#### ■ RENAISSANCE MARKET [TRC Plan Review #4]

##### TECHNICAL STANDARDS – ACCESS (driveway, sidewalk, and sight distance):

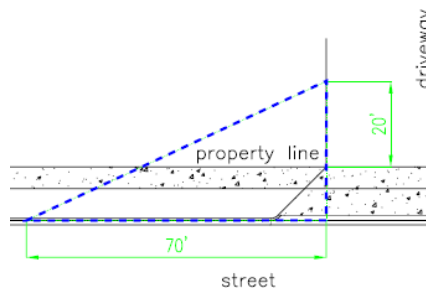
1. All the crosswalks are to be marked parallel to the direction of the vehicular traffic to minimize the maintenance of pavement markings due to wear off. [\[CofW SD 3-09 & SD 11-11\]](#).

The pavement markings shown in red, in the insert below demonstrates the meaning 'parallel to the direction of the vehicular traffic'. Pavement markings in red are not to scale and are only for the reference.
